FSUBDIVISION REVIEW SHEET

CASE NO.: C8J-2020-0047.1A

SUBDIVISION NAME: Jennings Place (Small Lot Subdivision)

**CITY OF AUSTIN –DEVELOPMENT SERVICES DEPARTMENT
SUBDIVISION APPLICATION – MASTER COMMENT REPORT**

SHEET
2 OF 5

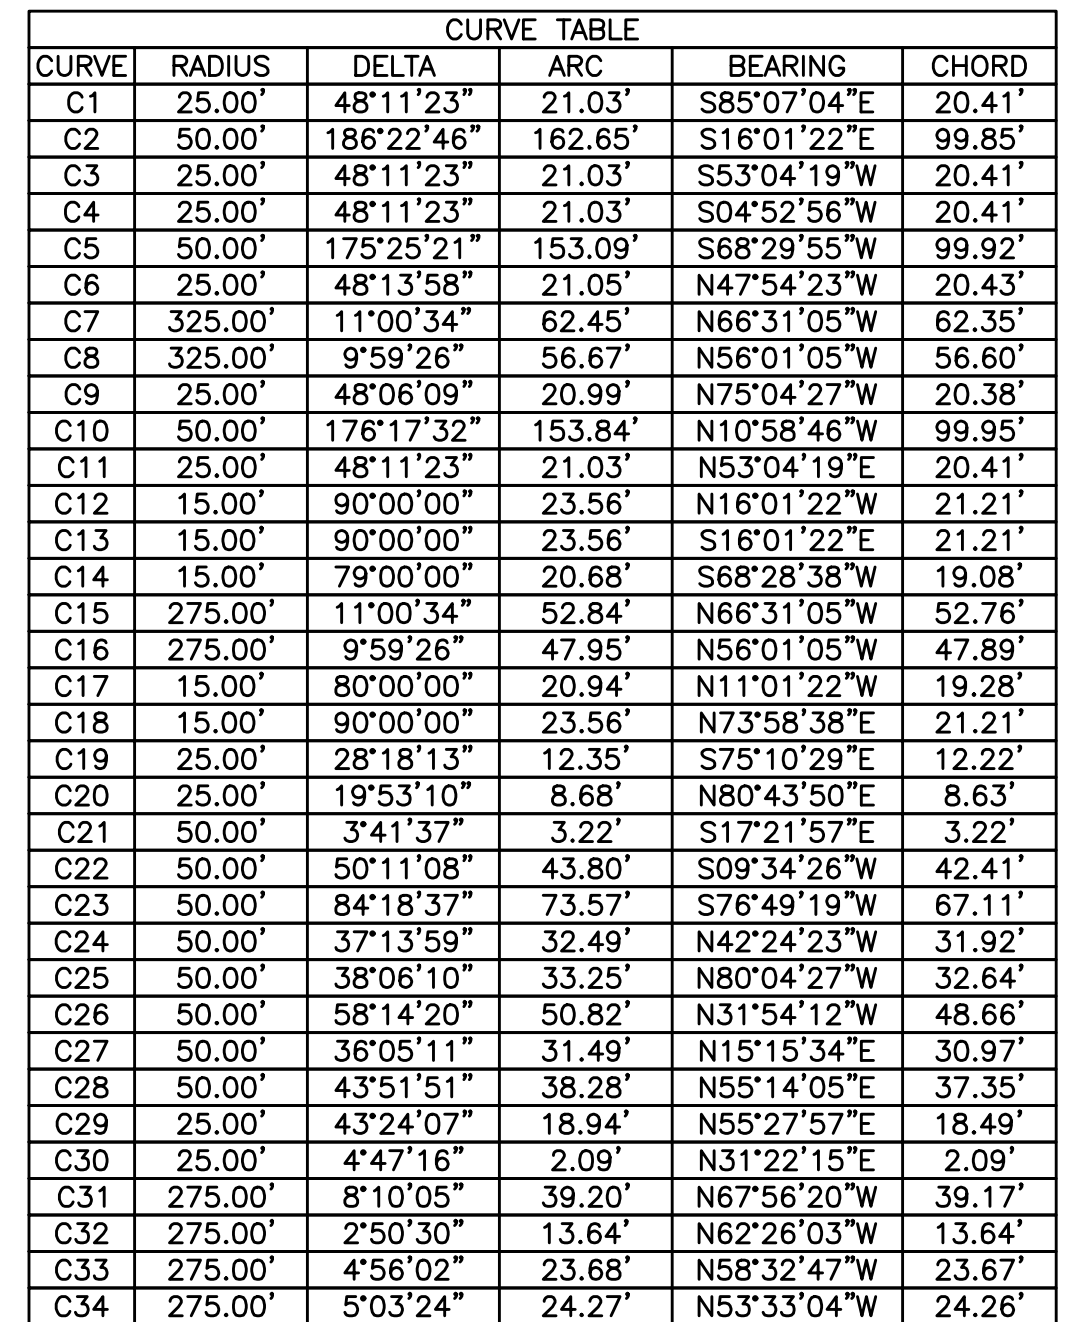
Fifteen foot electric distribution, electric telecommunications, and electric fiber easement is required adjacent to all street R.O.W. Show the easement(s) on the face of the plat.
